UNITED STATES
DEPARTMENT OF THE INTERIOR
BUREAU OF LAND MANAGEMENT
SUNDRY NOTICES AND REPORTS ON WELLS

5. Lease Serial No.	NM0405444-A
6. If Indian, Allottee or Tribe Name	
7. Unit or CA Agreement Name and No	
8. Well Name and No.	Todd 26L Federal 17
9. API Well No	30-015-36897
10. Field and Pool, or Exploratory	Ingle Wells; Delaware
11. County or Parish	State
Eddy	NM

TYPE OF SUBMISSION	TYPE OF ACTION			
☒ Notice of Intent	☐ Acidize	☐ Deepen	☐ Production (Start/Resume)	☐ Water Shut-Off
☐ Subsequent Report	☐ Alter Casing	☐ Fracture Treat	☐ Reclamation	☐ Well Integrity
☐ Final Abandonment Notice	☐ Casing Repair	☐ New Construction	☐ Recomplete	☒ Other Rig Layout Change
	☐ Change Plans	☐ Plug and Abandon	☐ Temporarily Abandon	
	☐ Convert to Injection	☐ Plug Back	☐ Water Disposal

13-5/8" 3K Annular

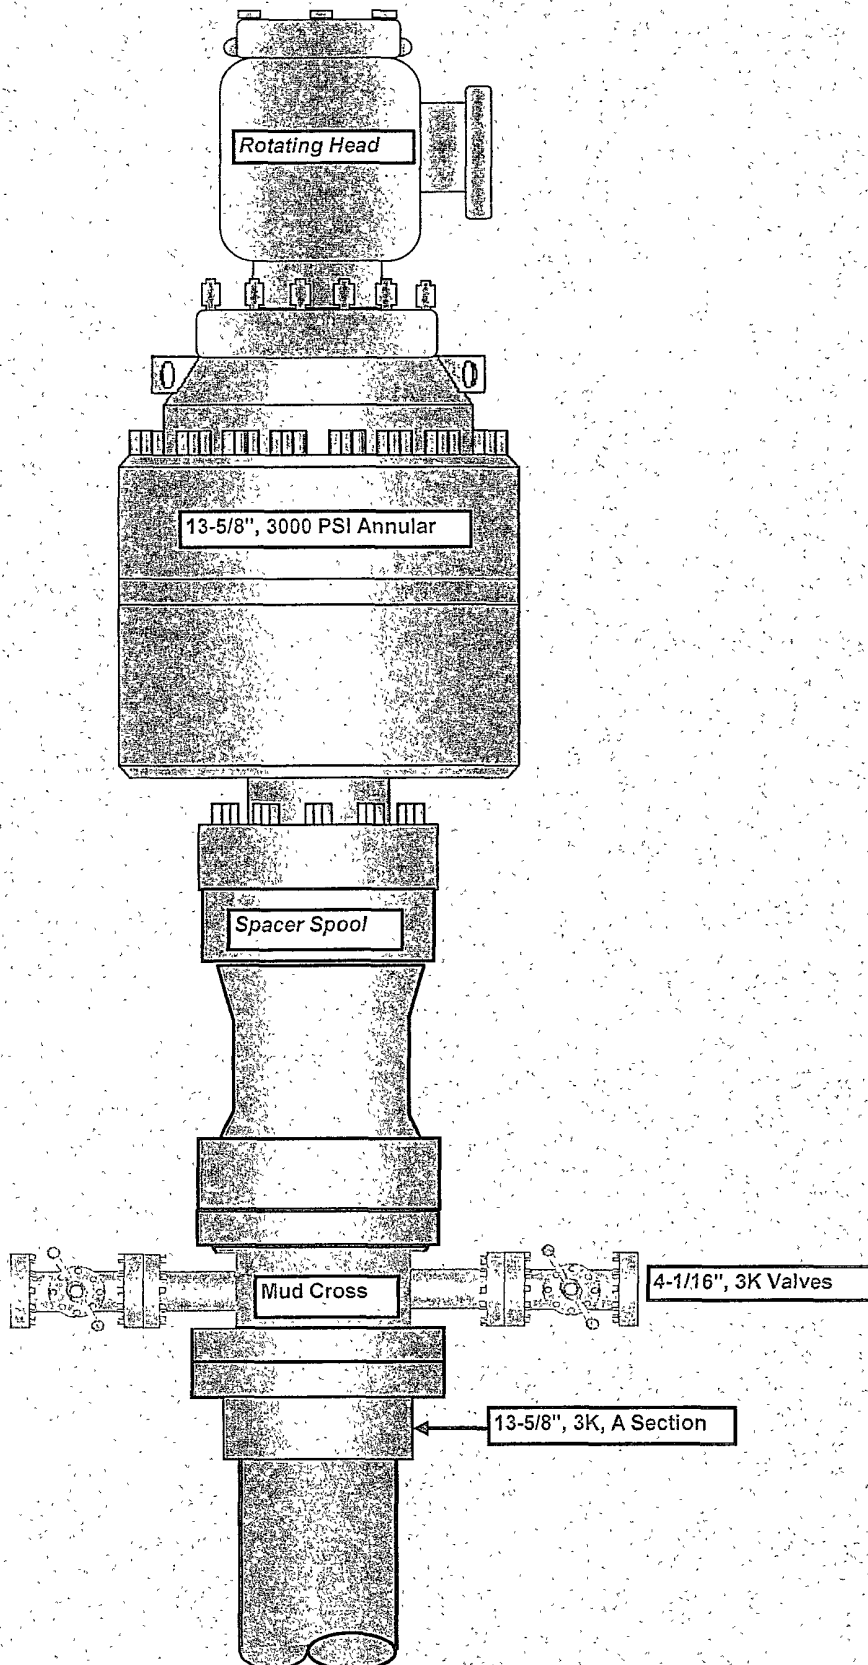
Devon Energy Production Company L. P. respectfully requests permission to change the Rig Layout from Basic Energy Services to Patterson 41. The 13 5/8" 3K Annular nipped up on the surface casing to drill the intermediate hole. Request variance to pressure test with rig pump prior to drilling intermediate hole. The 11" 5K Annular and double rams (pipe & blind) nipped up on the intermediate casing to drill the production hole.

Phone call with Mark Cooper - Devon, items not necessary
will use 0.0. II - 70% on surface casing. 11/25/09
